Australian Air Publication 721.79

ROYAL AUSTRALIAN AIR FORCE

VAMPIRE MODIFICATIONS

(Nos 401 to 500)

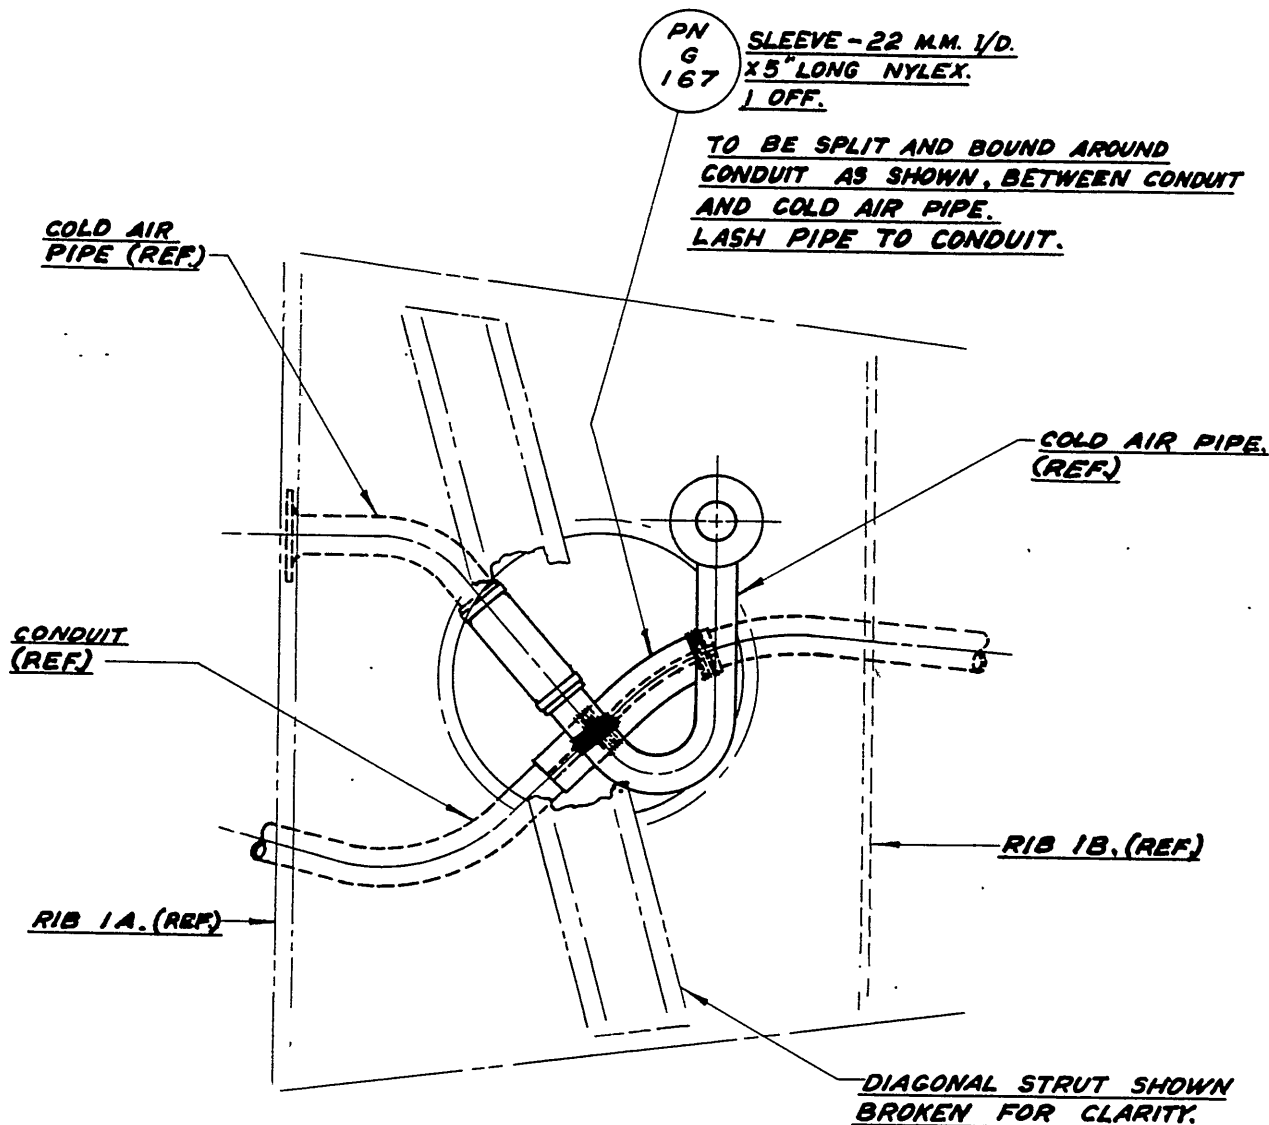
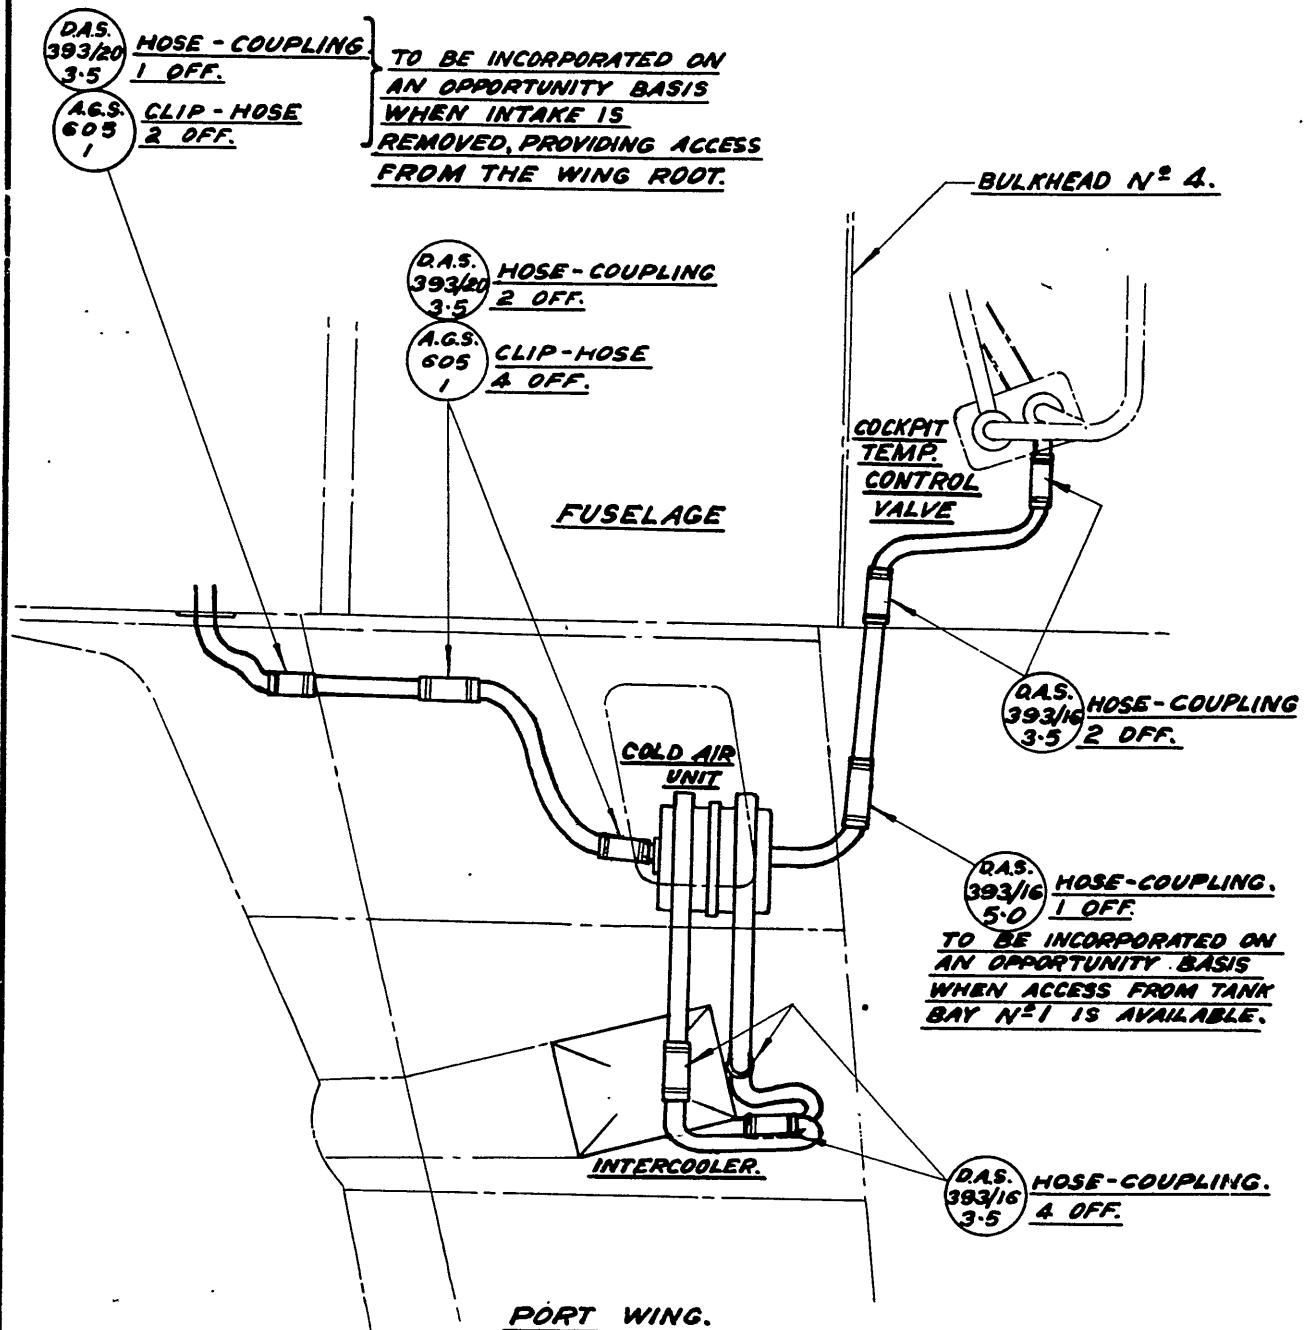
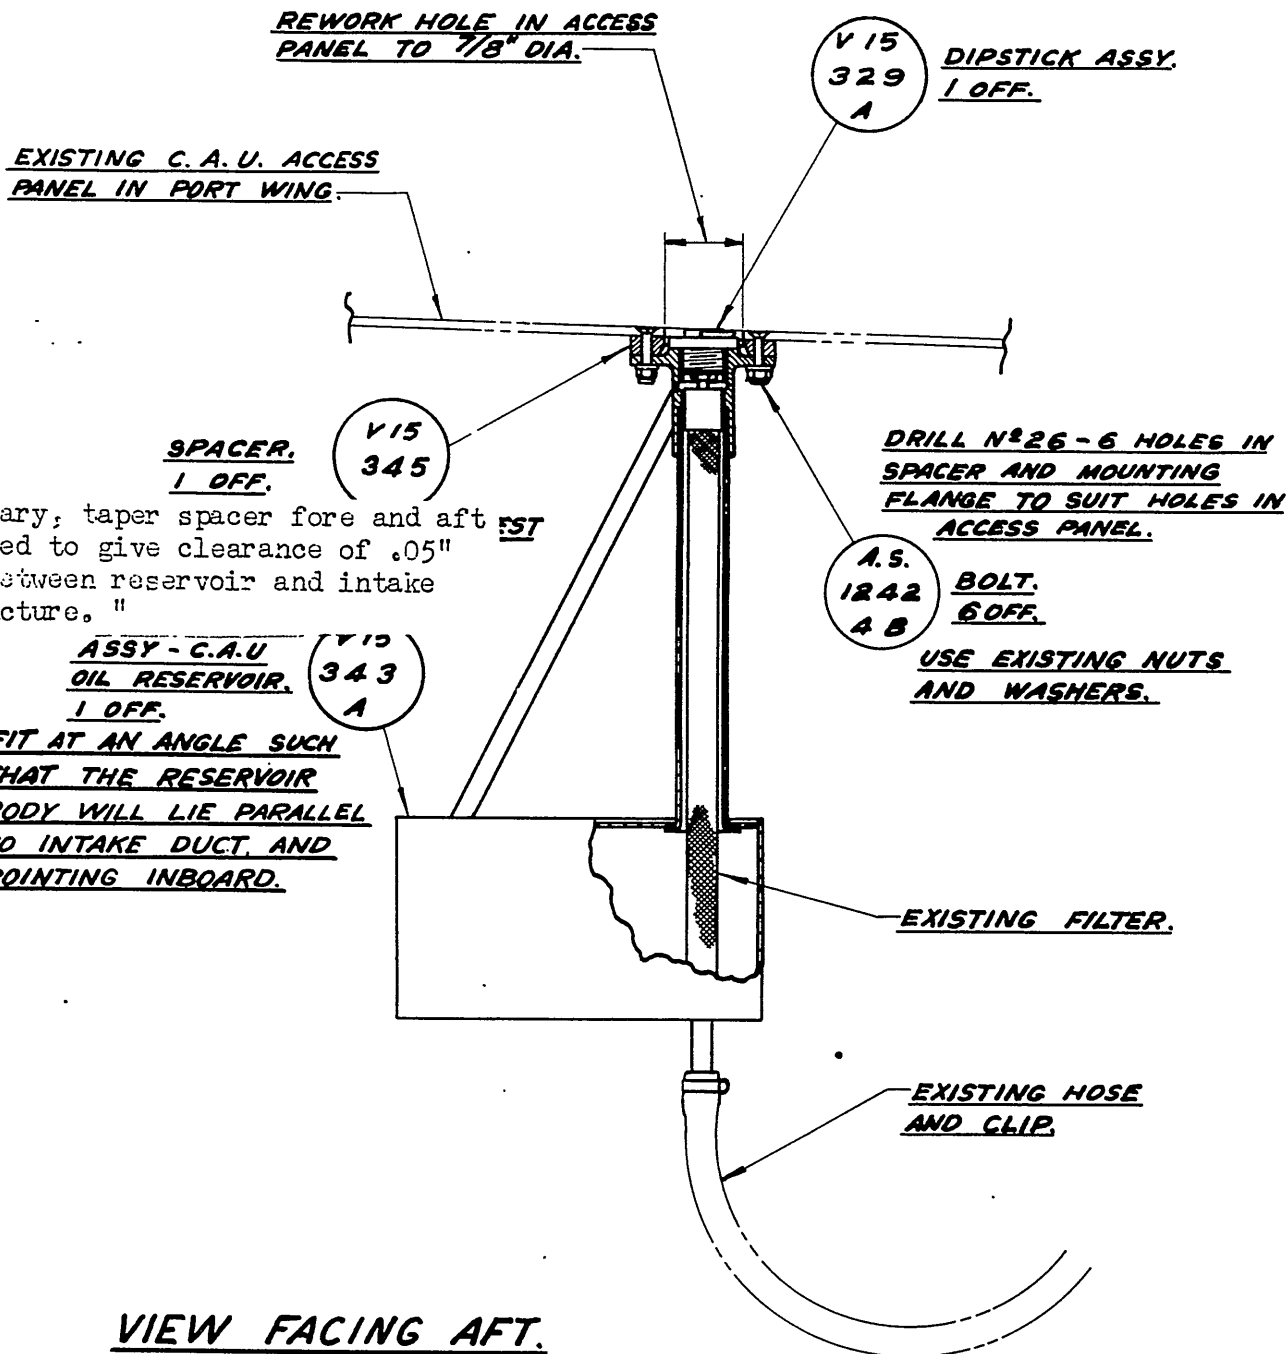
12. (a) Remove CAU access panel complete with oil reservoir from port wing.
- (b) Remove CAU from wing - AAP 721.79, Vol 1, Sect 3, Chap 8.
- (c) Remove upper engine inspection doors.
- (d) Split nylex sleeve (item 8) and bind to conduit using waxed cord (items 9 and 10) as shown on sheet 1 of Drawing No A15888.

- (e) Replace coupling hoses (items 15, 16 and 2 off item 17) and hose clips (item 18) with coupling hoses (items 4 and 5) and hose clips (item 6) as shown on sheet 2 of Drawing No A15888.
- (f) Replace CAU in wing - AAP 721.79, Vol 1, Sect 3, Chap 8.
- (g) Remove CAU oil reservoir (item 11) and packing (item 12) from access panel.
- (h) Rework access panel and fit CAU oil reservoir (item 1) If necessary spacer (item 2) is to be 3 bolts (item 7) with tapered in the fore and aft direction as shown on sheet 3 of to obtain a minimum of .05" clearance between reservoir and air intake duct aw dipstick assembly (item 3). in wing. Restore finish on spacer after reworking. " replace access panel, ~~on reservoir in wing.~~
- (l) Fill the reservoir to correct level with engine oil OEP 71.
- (m) Replace upper engine inspection doors.

if necessary, taper spacer fore and aft as required to give clearance of .05" minimum between reservoir and intake duct structure. "
